Colt Industries

**Fairbanks Morse
Engine Division**
701 Lawton Avenue
Beloit, Wisconsin 53511-5492
Telephone: 608/364-4411
Telecopier: 608/364-0382

Subject: 10 CFR 21 Report, Generator Failure
Baltimore Gas and Electric - Calvert Cliffs

Subject: 10CFR 21
Calvert Cliffs Nuclear Station
Alternator Failure/Colt Order #205706

FDG 53085

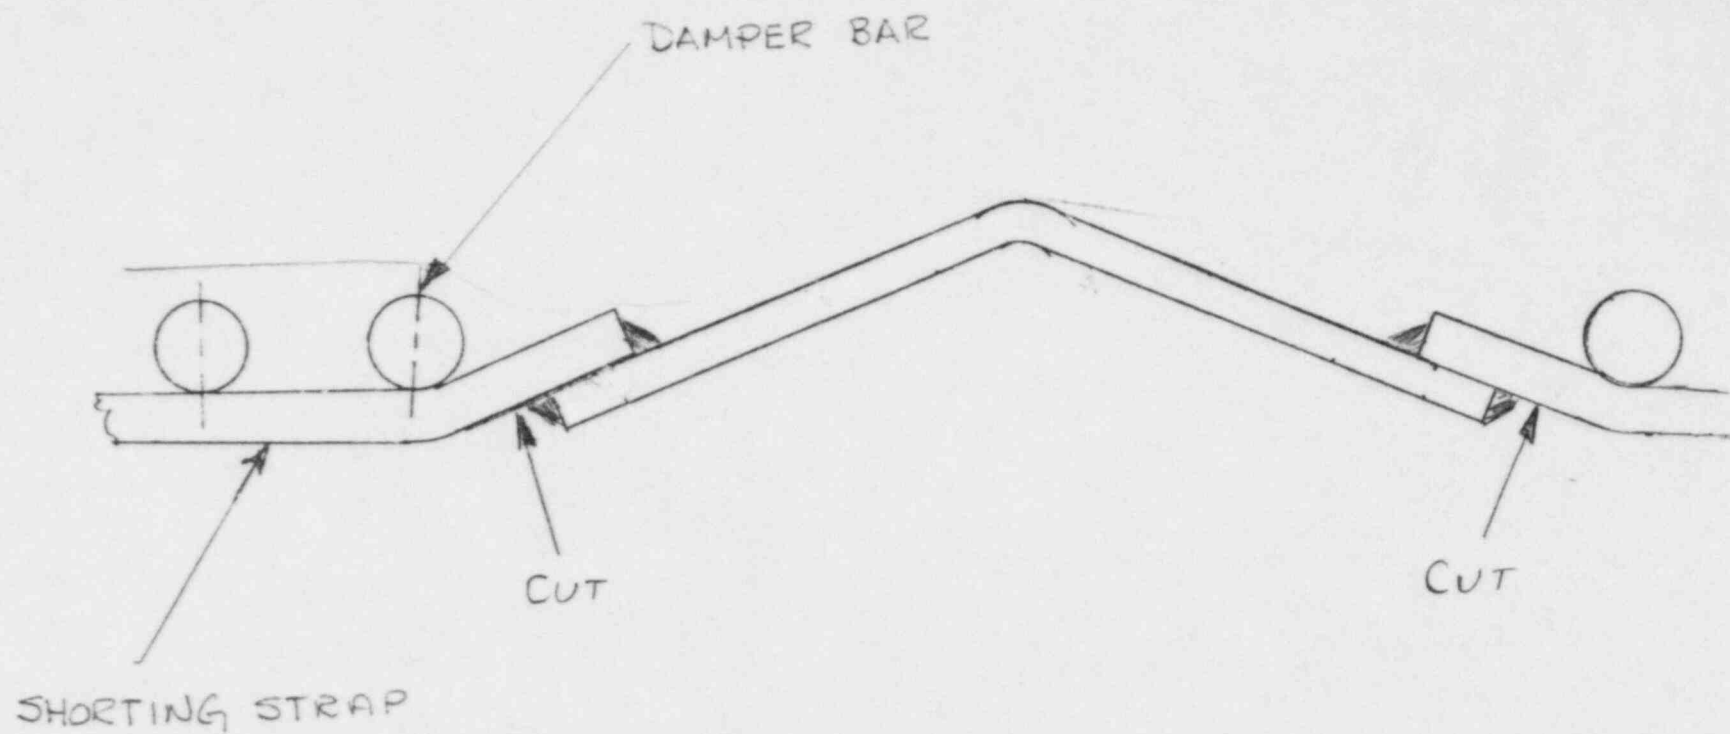
Based on the views expressed in the "principle functions" discussion above, and in view of the above listed installations, it is the recommendation of Louis Allis that the interpolar connectors be removed from the units at Installations 1-4 as noted above.

Enclosed is a sketch #53085 indicating where the shorting bar should be severed.

1. Since the shorting strap under the damper bars is made of soft material, it may be possible to reach into the generator with a bolt cutter and cut the connector and part of the shorting bar in two and remove the connector. Care must be taken not to allow chips or slivers from the severed part to drop into the machine.
2. Disassemble the rotor from the unit and proceed with Item 1 above.
